**BALTIMORE COUNTY, MARYLAND
DEPARTMENT OF PUBLIC WORKS AND TRANSPORTATION
DIVISION OF CONSTRUCTION CONTRACTS ADMINISTRATION
111 WEST CHESAPEAKE AVENUE
TOWSON, MARYLAND 21204**

Contract No. 25010 PO0
Project No's. 107011861
Jacksonville Senior Center Expansion -
3605 Sweet Air Road, Phoenix, Maryland 21131
Phoenix – District 10c3

ADDENDUM NO. 1

DATE: 8/8/2025

ARL:\BKM\A-01\Projects\23127\Drawings\A-01\E003 - SITE PLAN

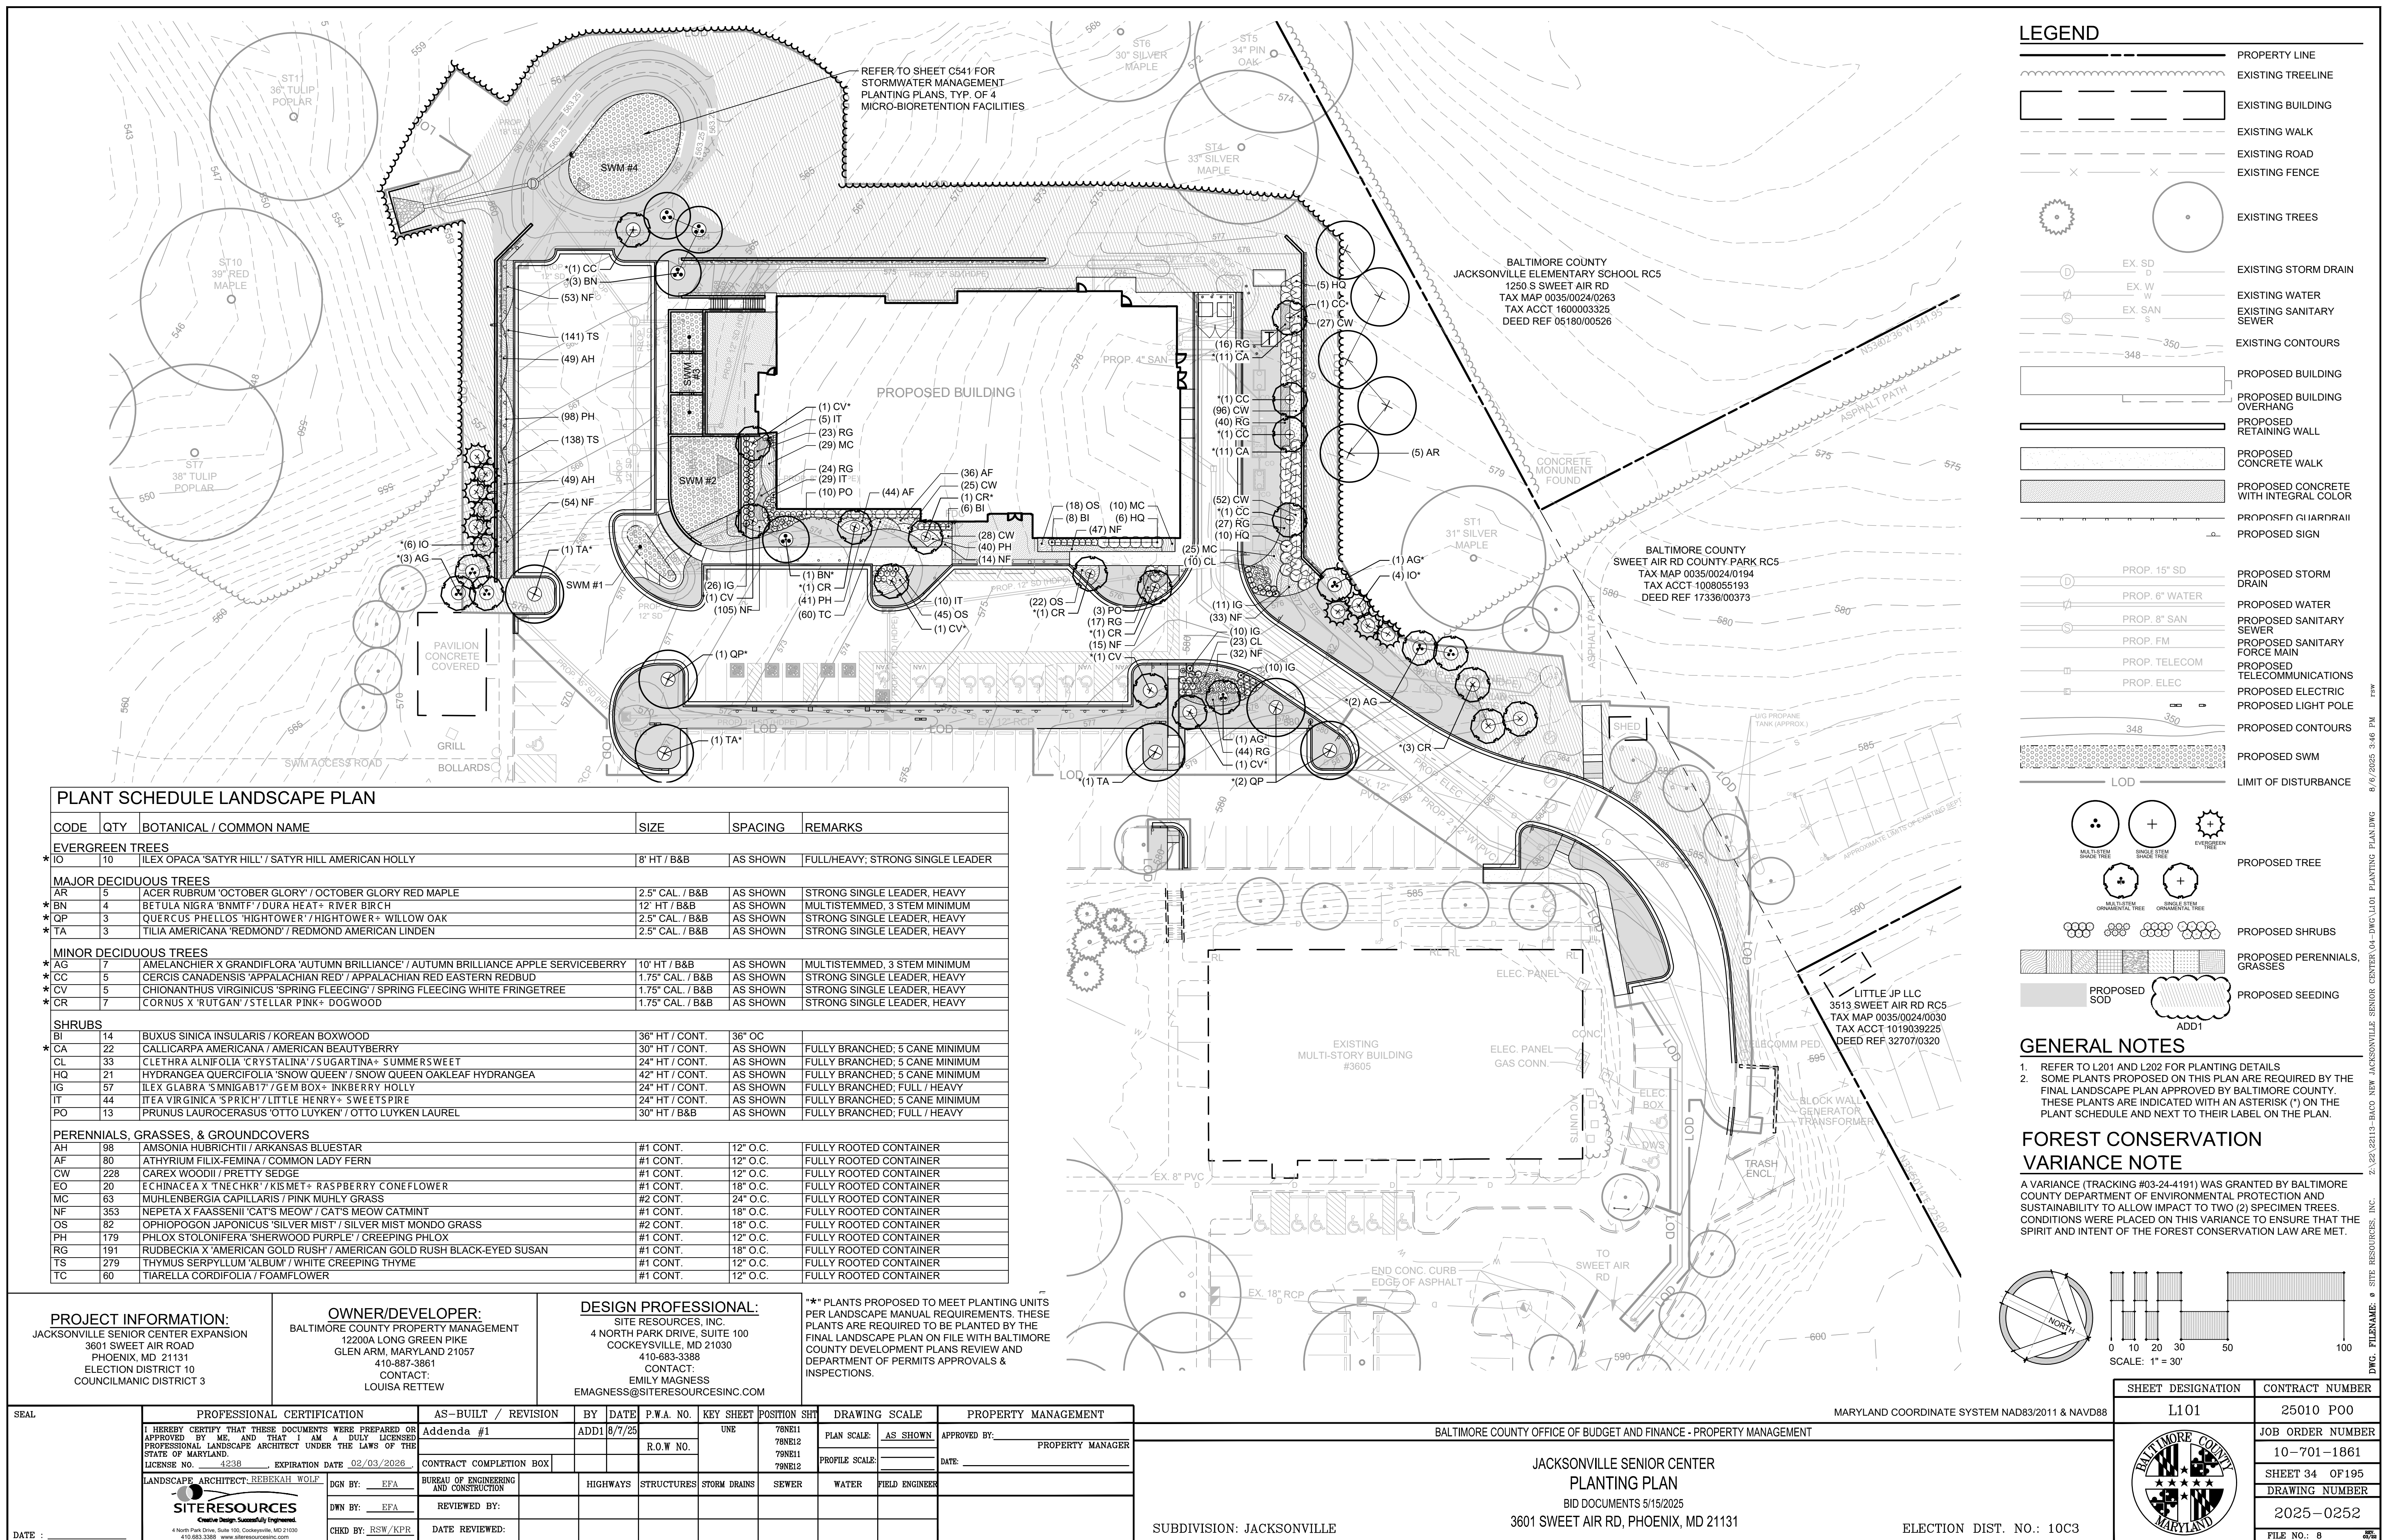
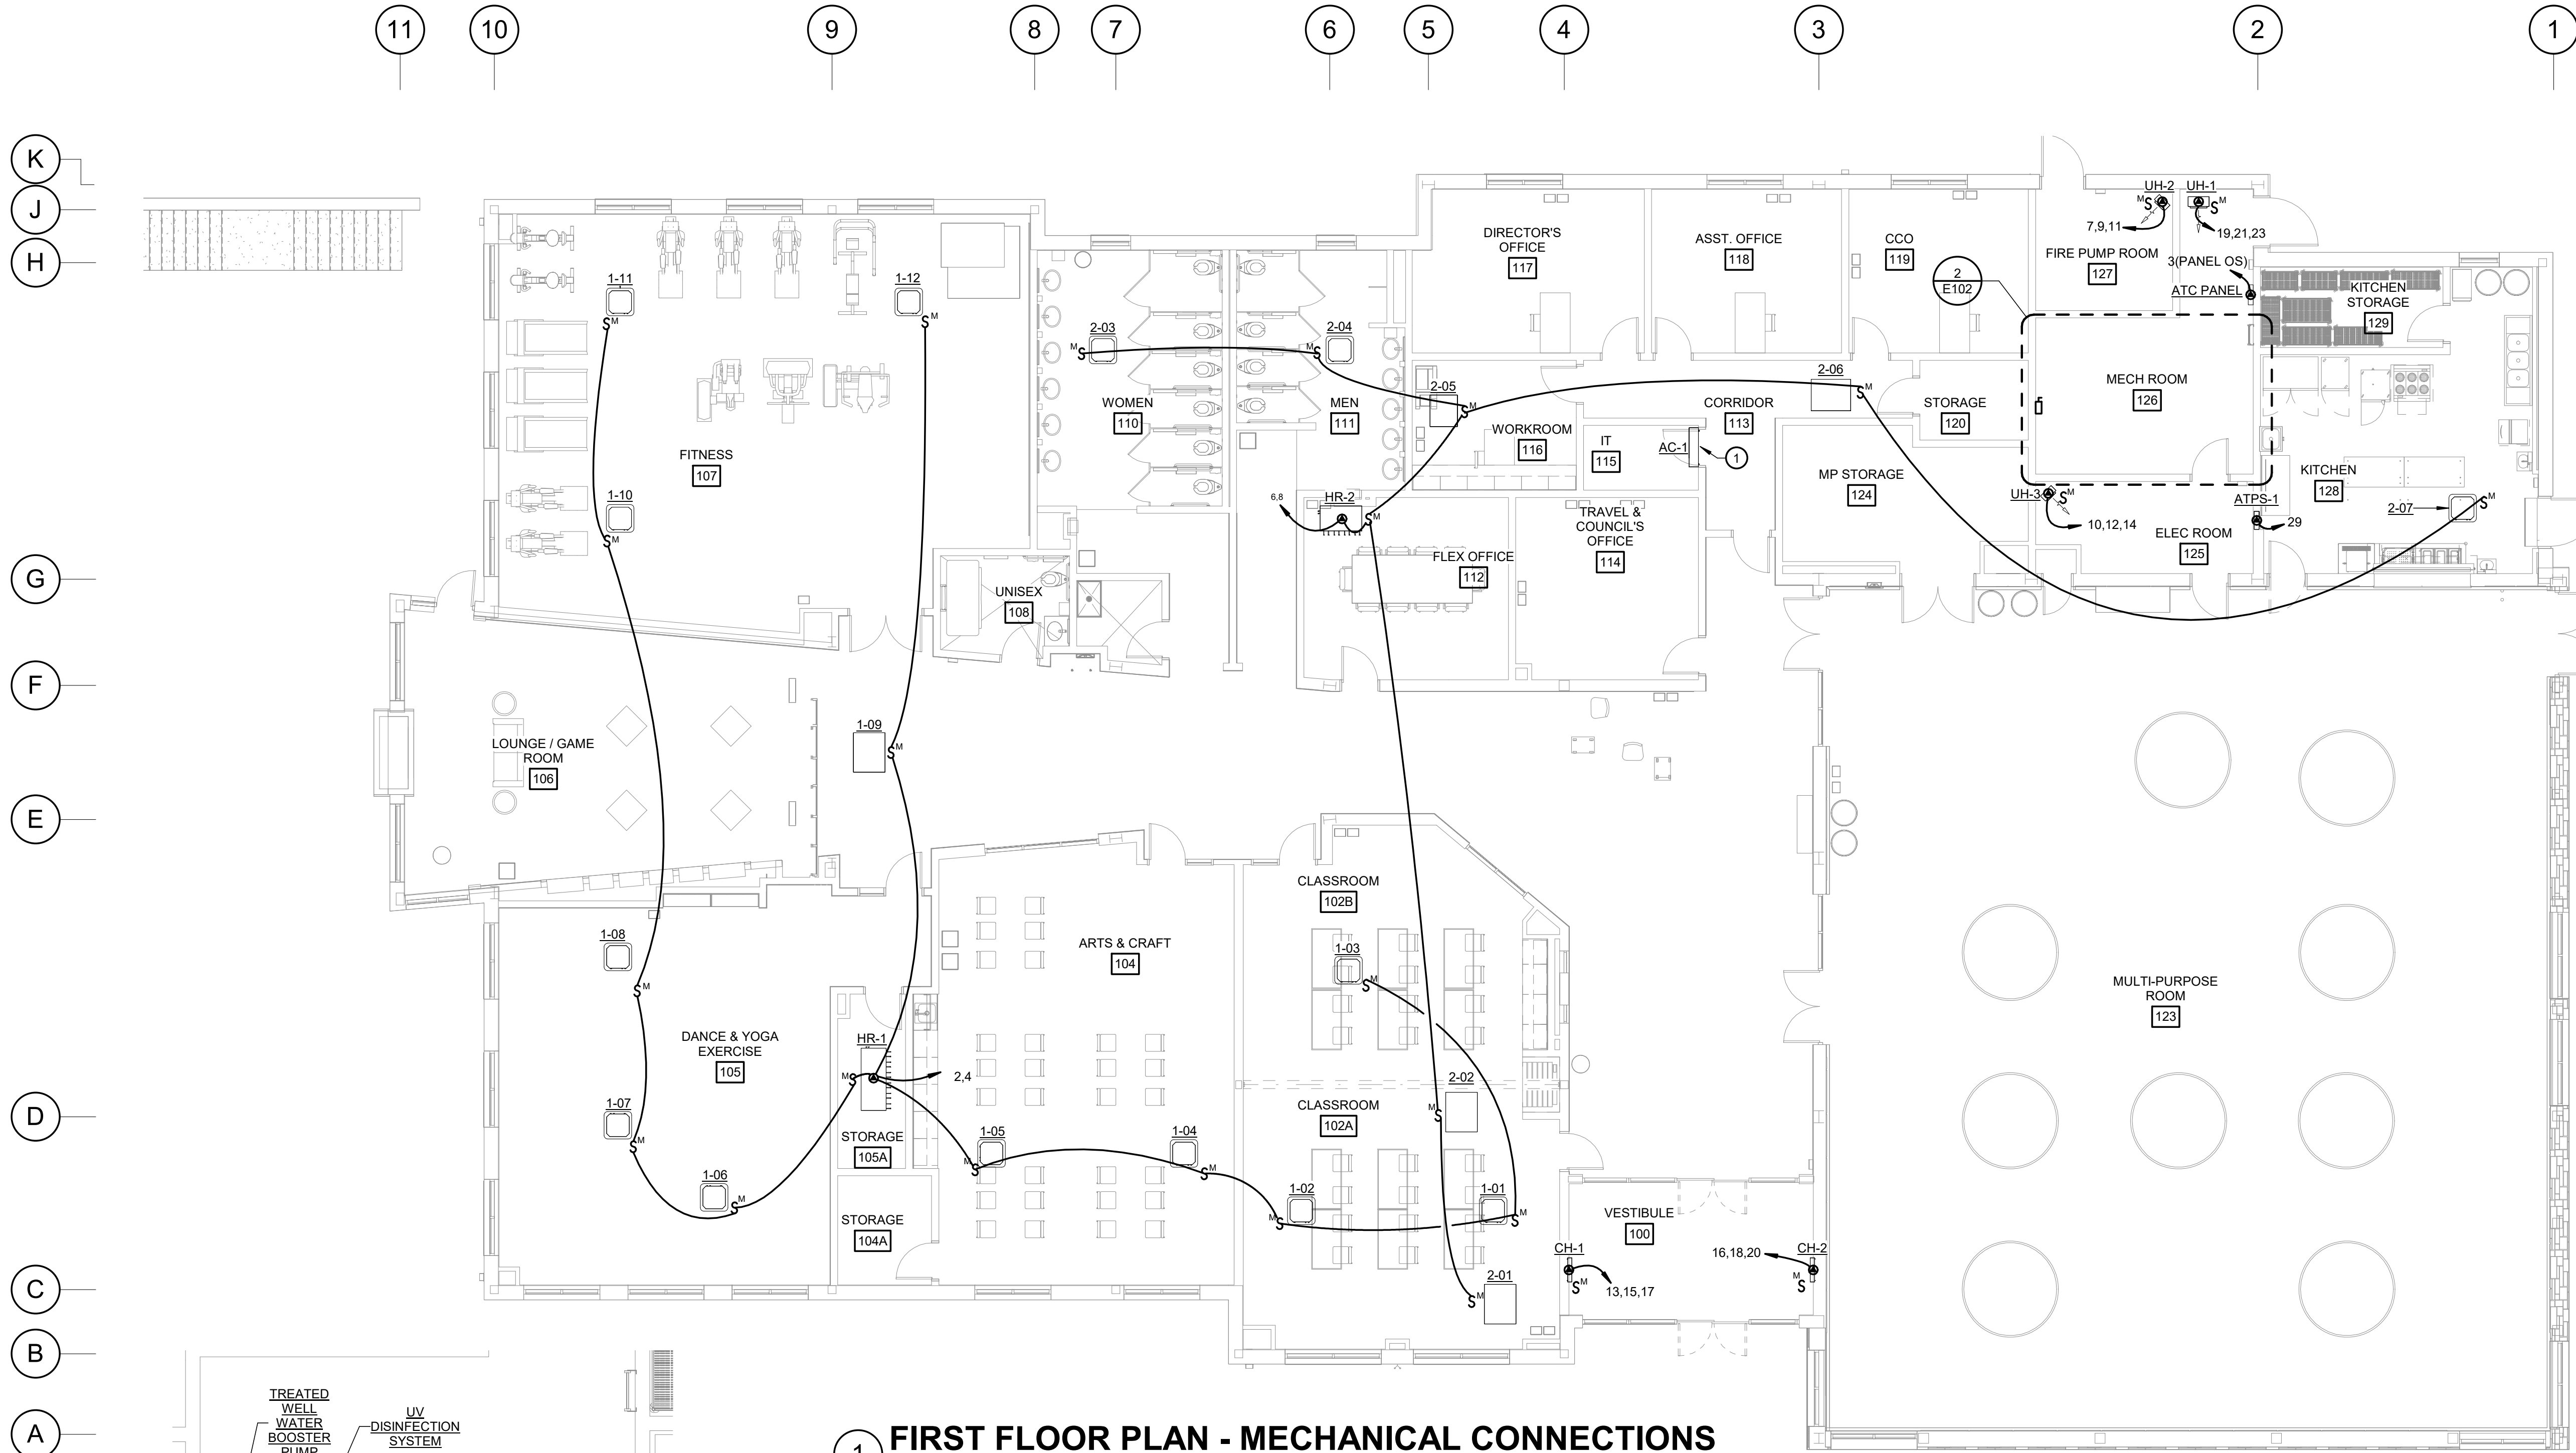
61	Please provide details on transformer and generator pads.	Transformer pad is 78"x66"x6"D and should be coordinated with BGE. See revised sheet E003
62	Please provide fire pump control specifications for electric-drive, vertical turbine fire pump equipment in Section 213213.	21 32 13 specifications will be revised to include fire pump controller information.
63	Reference pump station: The pumps specified only have a 3 year published warranty, the job specifications call for a 5 year published warranty.	Provide warranty as required in specifications. See revised Spec 21 32 13.
64	The specifications call for the pump to have seal failure alert. The pumps specified and any sewage pump under 2 hp are not available with seal fail alert.	spec section 42 25 13.40 to be revised and called Submersible Effluent Pumps Remove spec section 40 90 00 instrumental and control entirely.
65	Will the Electrical Contractor be responsible for consumption charges or will the GC pay these?	That is between general contractor and electrical contractor. GC, will be billed for any consumption prior to substitutional completion.

73	On the site drawing E003 drawing note #14 it indicates that 4 of the existing site lighting poles are to be reused with new fixture heads installed on them. I have looked at the civil drawings and I don't see any information regarding these existing light poles. My question is, are these 4 existing poles being reinstalled in the same location using the same pole bases? Or are these new locations requiring new bases and conduit?	Four existing light poles are to be salvaged - refer to sheet C111, Demolition Note D-7. The existing poles will be reinstalled in new locations with new bases and conduit as shown on sheet E003.
74	For the building I noticed that the architectural and the structural foundation walls show different depths for example on the structural foundation plan at the south west corner of the building it calls out the top of the footer being (-12.00') below the slab on the architectural plans I never saw a wall section or a building section showing a wall anywhere close to this depth. Which set of plans are accurate?	Follow structural plan for foundation depth.
